SERVICE PROCEDURE

REFERENCE: FSA 202503

SUBJECT: Side Skirt and EGT Sensor Contact

FSA TYPE: Next Service Visit

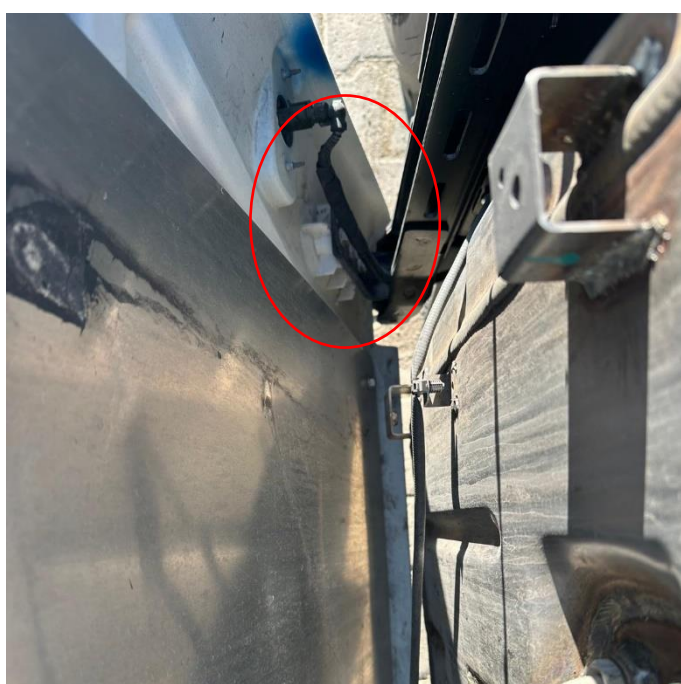
This document details have been prepared for the removal and non-reattachment of the heat shield inside the side skirt of H566 vehicles due to the interference between the EGT cables on the side skirt and muffler, which causes damage to the cables.

1. The side skirt is carefully unfolded. Then, the rope connections are detached, and the side skirt is fully lowered.

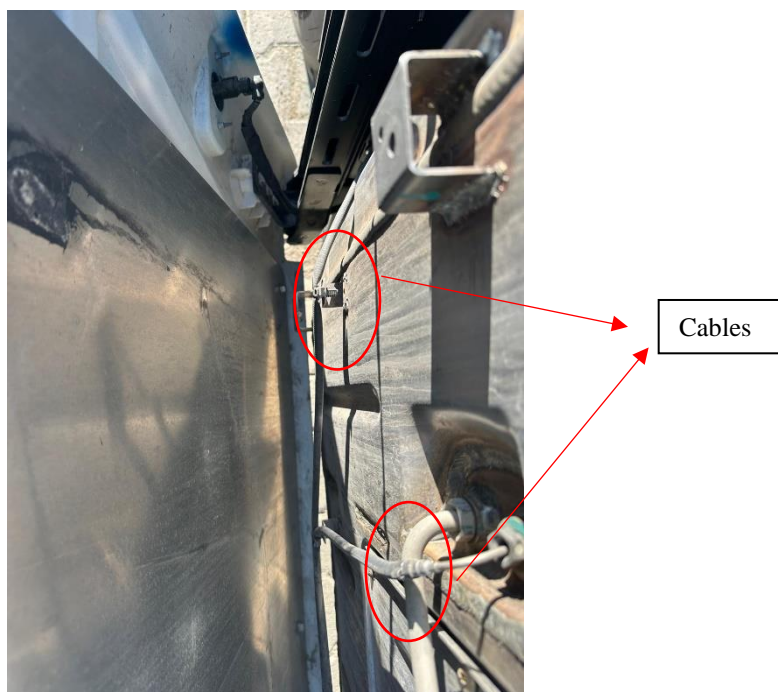
2. The connections with the heat shield are detached. **Then, the heat shield is removed and will not be reattached.**

3. Then, the EGT cables on the muffler are visually inspected for any damage. **If damage is suspected, the EGT cables are replaced with new ones. (Cable no GC46-12B591-DB)**

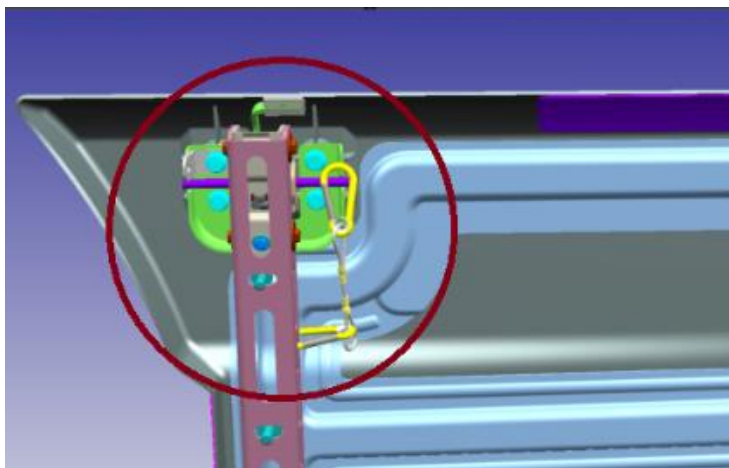
5. The ropes are attached, and it is checked whether the ropes perform their function when the side skirt is released.

6. After ensuring that the side skirt is properly mounted and does not move, the vehicle is a short regeneration is done for muffler inspection.
